CONTRACT CHANGE ORDER NO. ____
SHEET ___ OF ___

MARK	DATE	DESCRIPTIONS	BY	CH'D	CCO#
3	08/10/12	TOWER CAULKING	NV	MN	256
2	07/07/08	CAULKING	MN	NV	66
1	06/23/06	SPLICE PLATES PER ISM	MN	NV	21

SAN FRANCISCO OAKLAND BAY BRIDGE
EAST SPAN SEISMIC SAFETY PROJECT
SELF-ANCHORED SUSPENSION BRIDGE
(SUPERSTRUCTURE & TOWER)

TOWER SPLICE DETAILS NO. 3

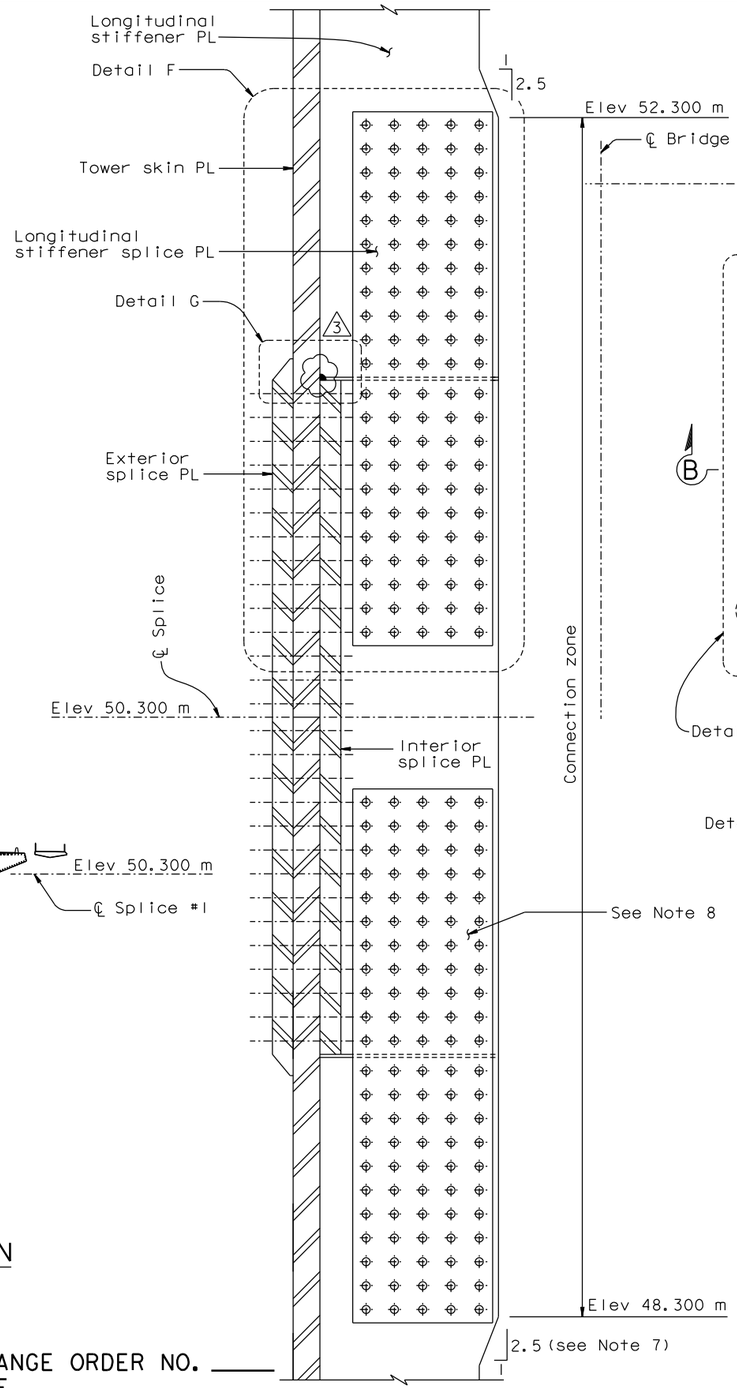
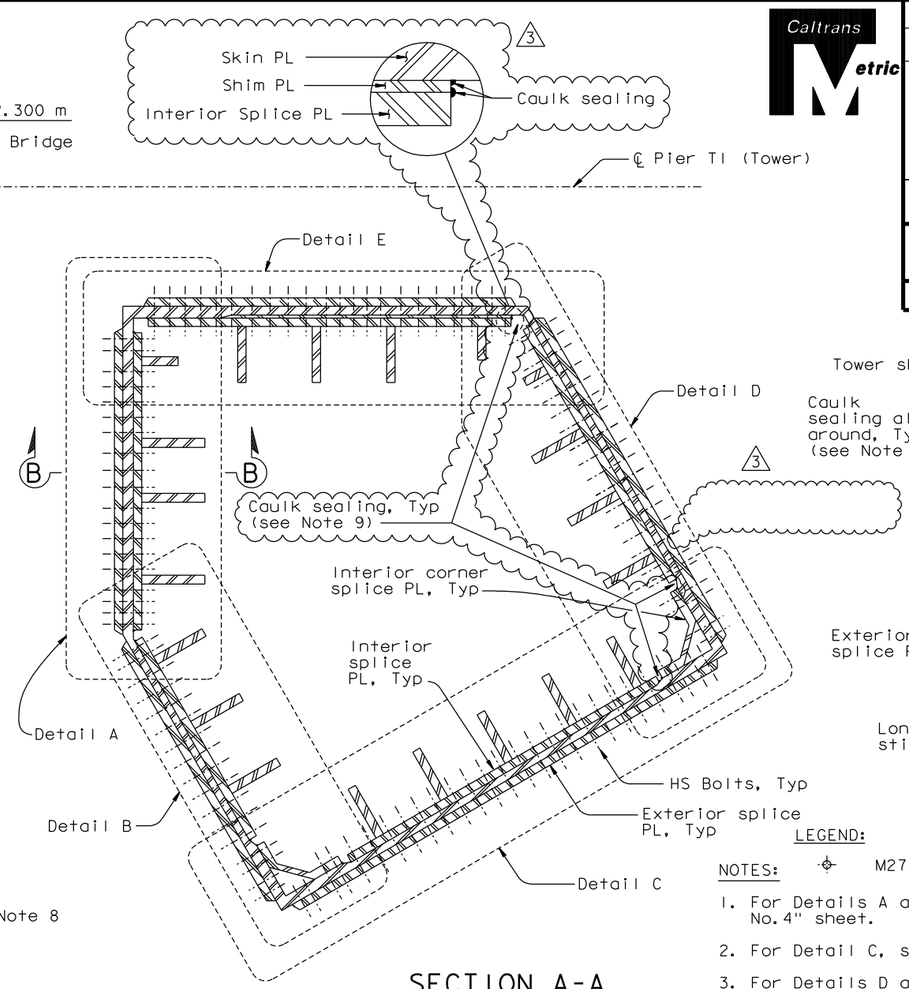
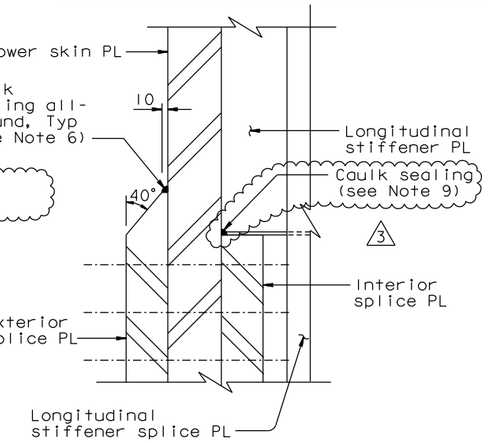
8. For stiffeners A1, B4, E4, E7, and D4, see "Tower Splice Details No.7" sheet.
3. 9. Caulk sealing shall be applied along the exposed upper horizontal edge and exposed vertical edges of all interior splice plates, interior corner splice plates, and shim plates. For upper horizontal edges, caulk sealing shall be continuous through the longitudinal stiffener plates by filling the gap between longitudinal stiffener plates and interior splice plates.

TOWER SPLICE DETAILS NO. 8

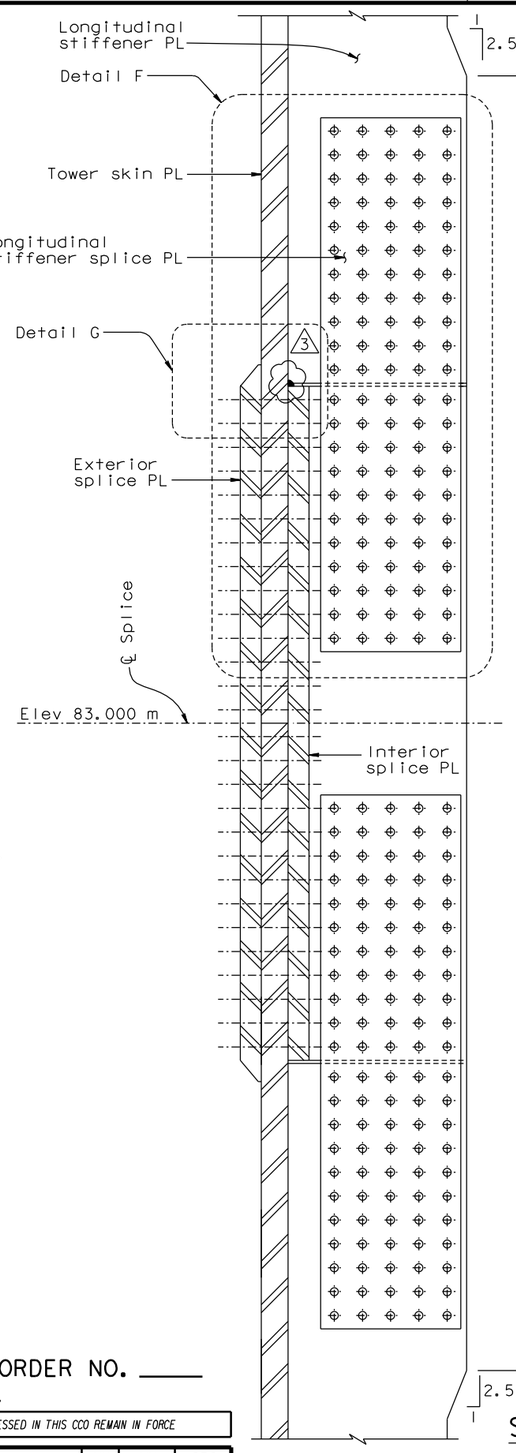
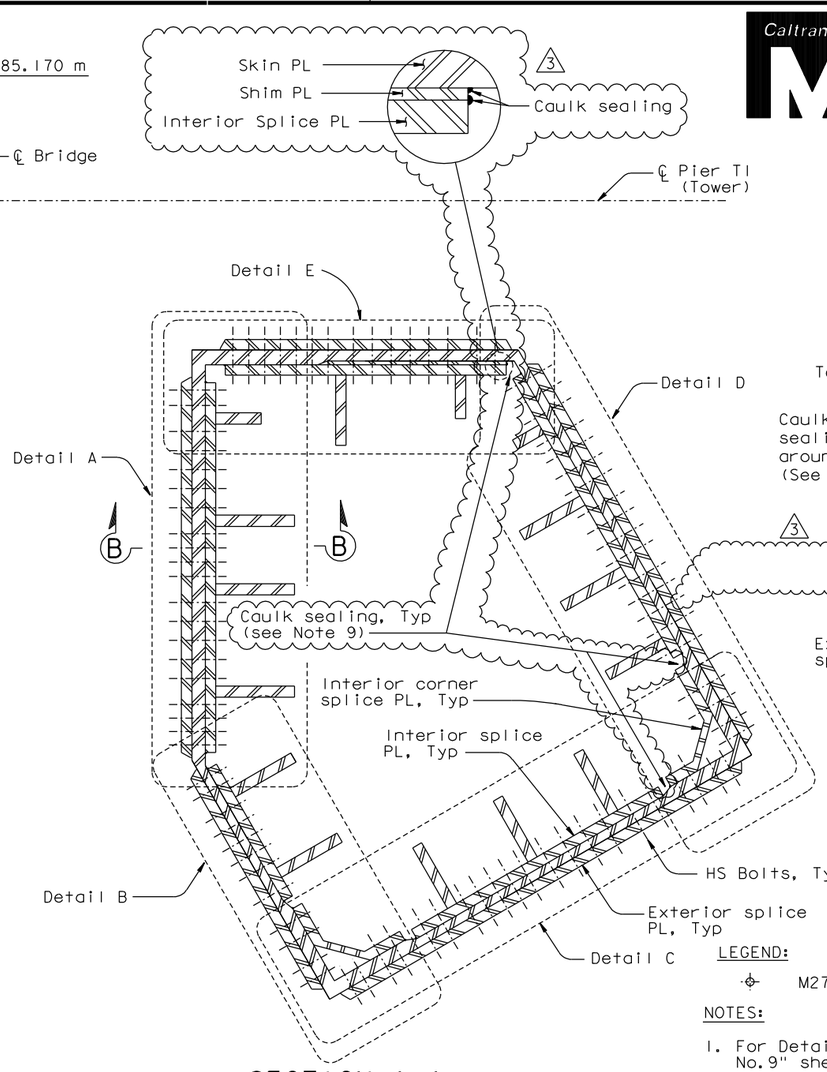
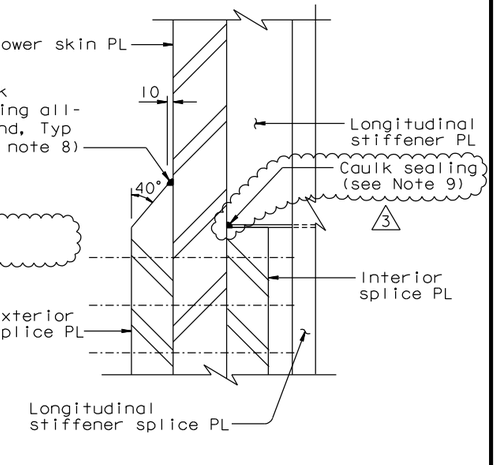
3 9. Caulk sealing shall be applied along the exposed upper horizontal edge and exposed vertical edges of all interior splice plates, interior corner splice plates, and shim plates. For upper horizontal edges, caulk sealing shall be continuous through the longitudinal stiffener plates by filling the gap between longitudinal stiffener plates and interior splice plates.

MARK	DATE	DESCRIPTIONS	BY	CH'D	CCO#
3	08/10/12	TOWER CAULKING	NV	MN	256
2	07/07/08	CAULKING	MN	NV	66
1	06/23/06	SPLICE PLATES PER ISM	MN	NV	21

TOWER SPLICE DETAILS NO. 13

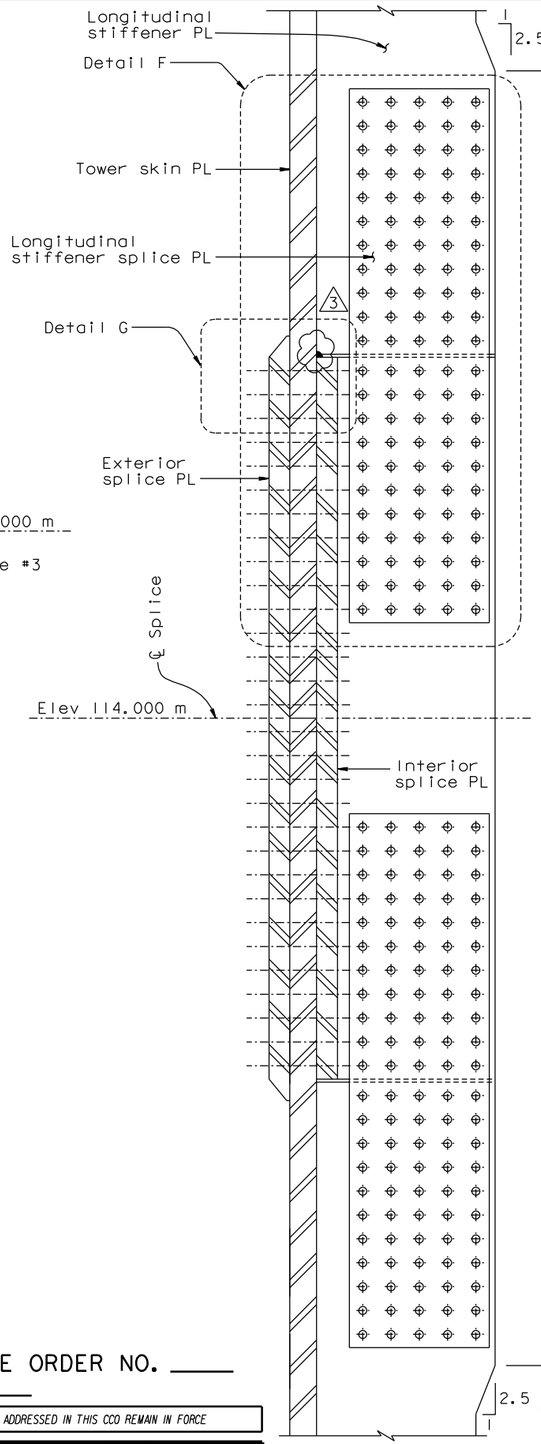
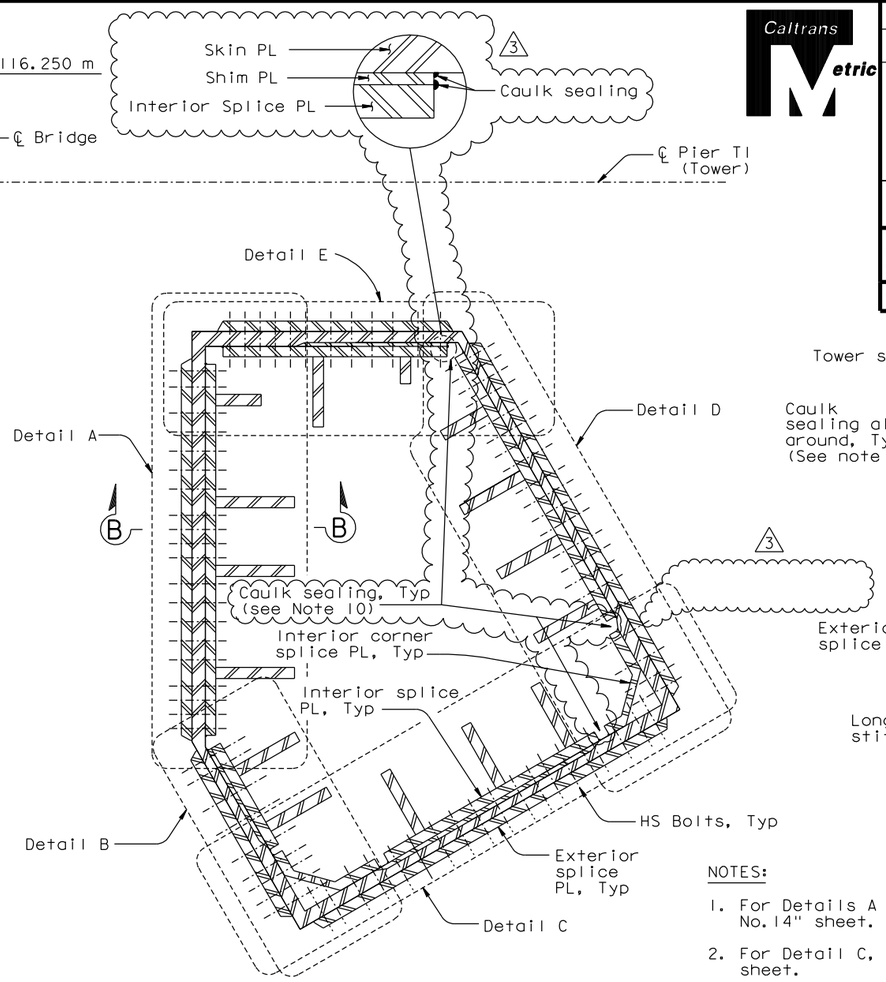
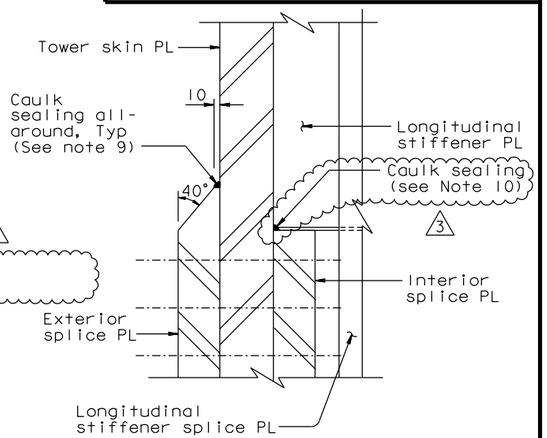
3 10. Caulk sealing shall be applied along the exposed upper horizontal edge and exposed vertical edges of all interior splice plates, interior corner splice plates, and shim plates. For upper horizontal edges, caulk sealing shall be continuous through the longitudinal stiffener plates by filling the gap between longitudinal stiffener plates and interior splice plates.

MARK	DATE	DESCRIPTIONS	BY	CH'D	CCO#
3	08/10/12	TOWER CAULKING	NV	MN	256
2	07/07/08	CAULKING	MN	NV	66
1	06/23/06	SPLICE PLATES PER ISM	MN	NV	21

TOWER SPLICE DETAILS NO. 18

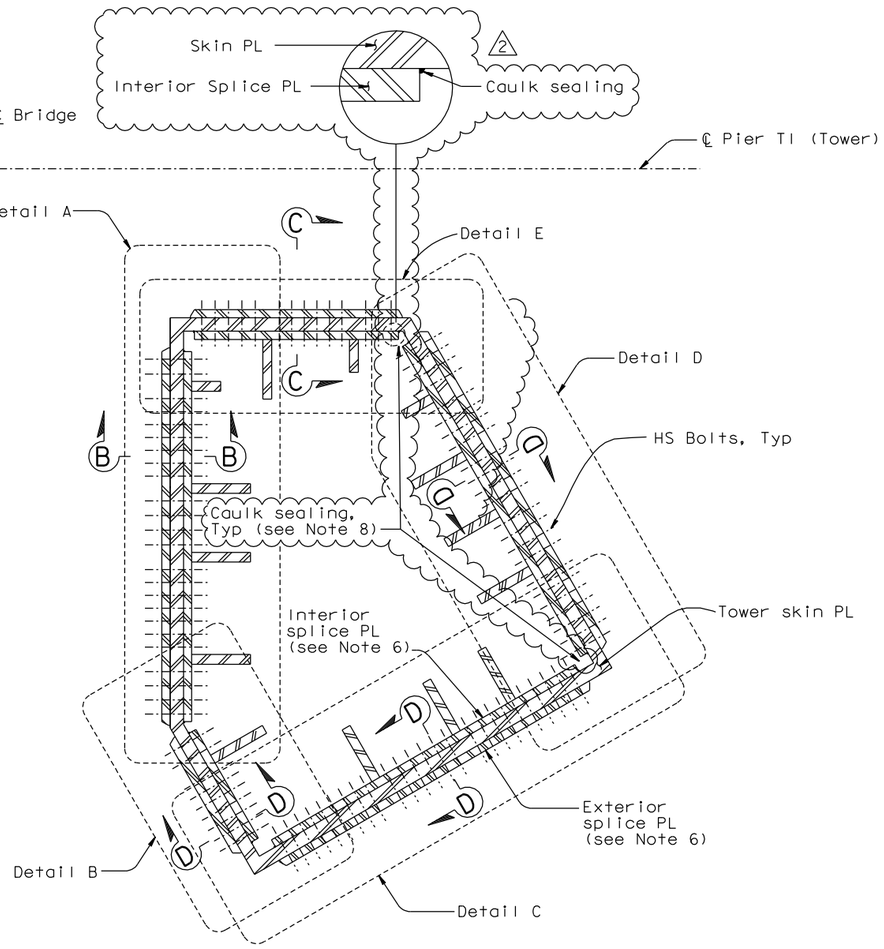
7. The tower splice connections are designed as slip critical connections with class B contact surface (slip coefficient 0.5). The Contractor shall ensure that the flatness requirements are met at the faying surfaces.
2 8. Caulk sealing shall be applied along the exposed upper horizontal edge and exposed vertical edges of all interior splice plates, interior corner splice plates, and shim plates. For upper horizontal edges, caulk sealing shall be continuous through the longitudinal stiffener plates by filling the gap between longitudinal stiffener plates and interior splice plates.

MARK	DATE	DESCRIPTIONS	BY	CH'D	CCO#
2	08/10/12	TOWER CAULKING	NV	MN	256
1	06/23/06	SPLICE PLATES PER ISM	MN	NV	21
		REVISIONS

TOWER SPLICE DETAILS NO. 19

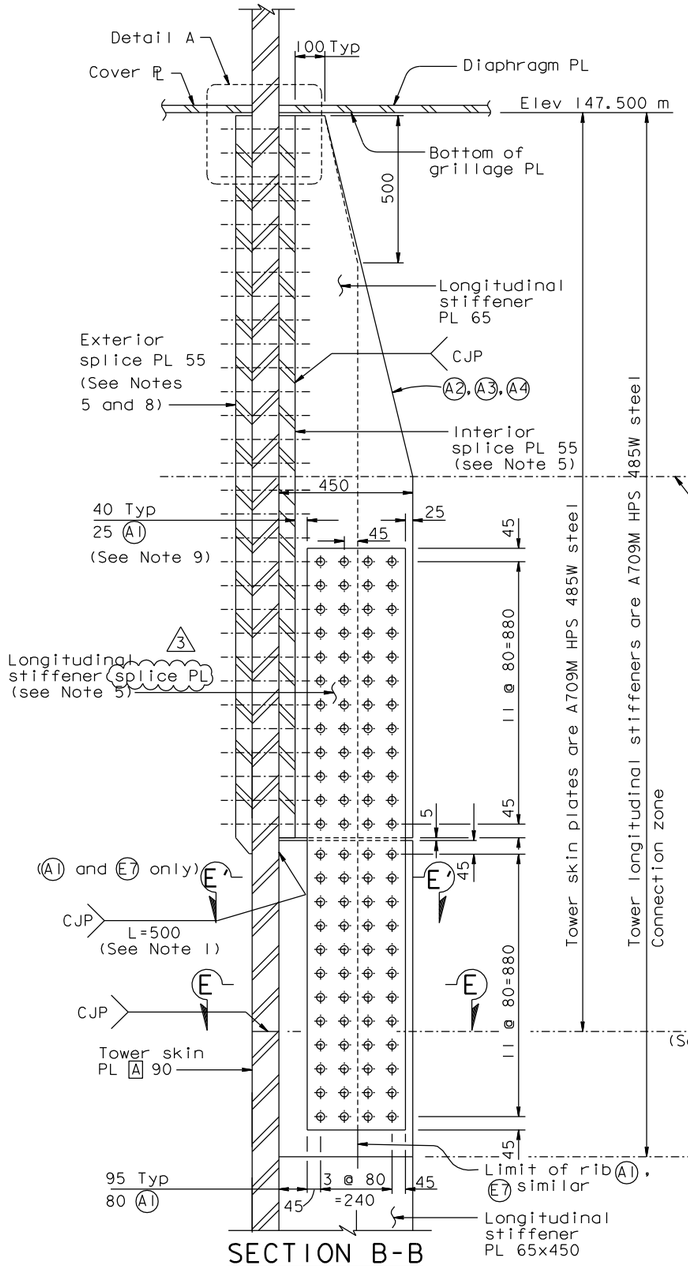
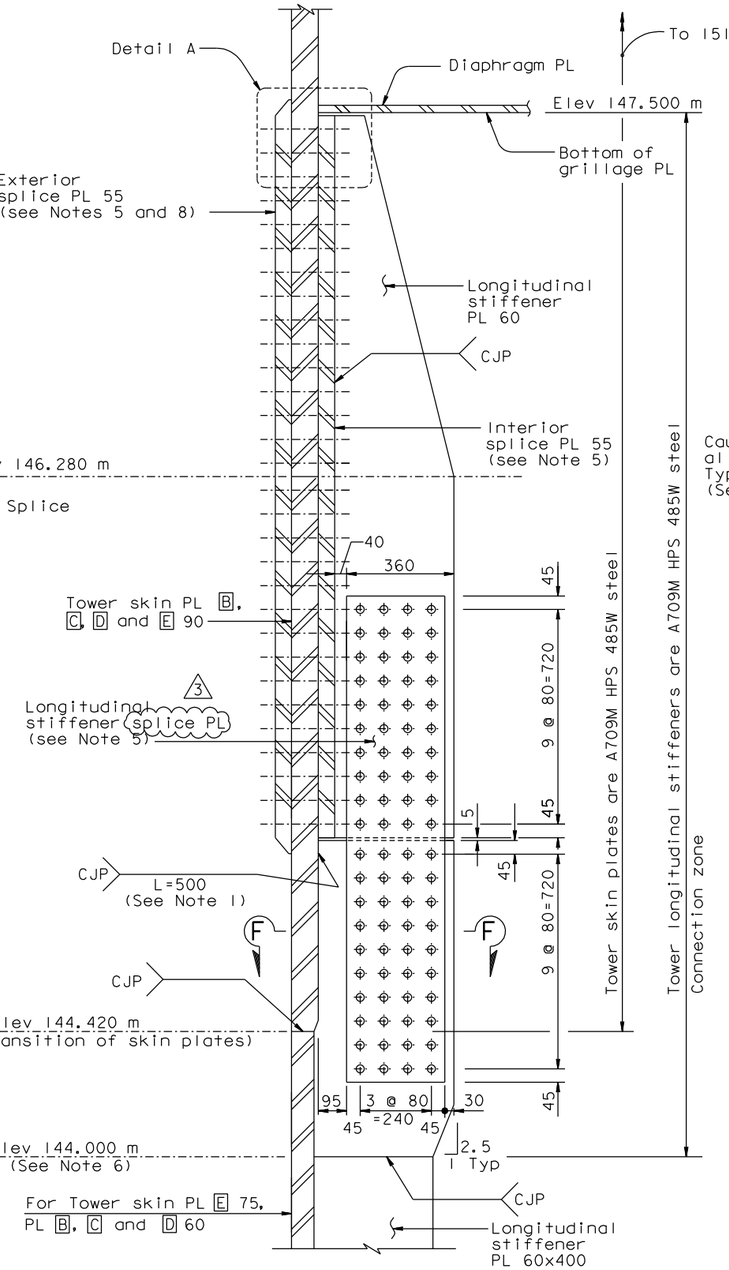
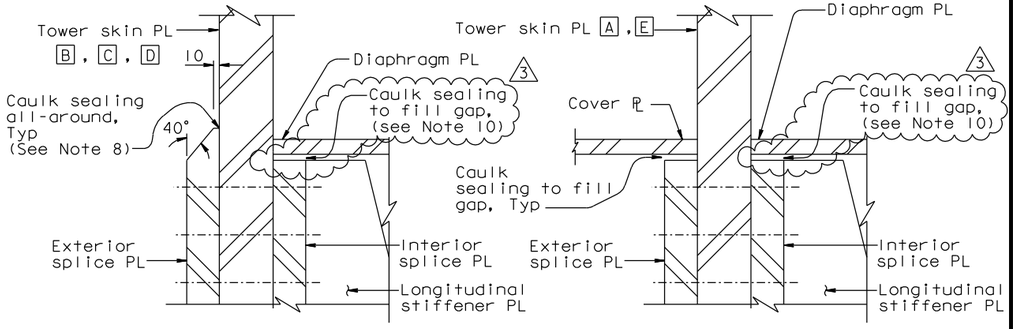
3 10. Caulk sealing shall be applied along the exposed upper horizontal edge and exposed vertical edges of all interior splice plates. For upper horizontal edges, caulk sealing shall fill the gap between the diaphragm plates and interior splice plates.

MARK	DATE	REVISIONS	BY	CH'D	CCO#
3	08/10/12	TOWER CAULKING	NV	MN	256
2	07/07/08	CAULKING	MN	NV	66
1	06/23/06	LONG. STIFFENER GAP & MISC.	MN	NV	21
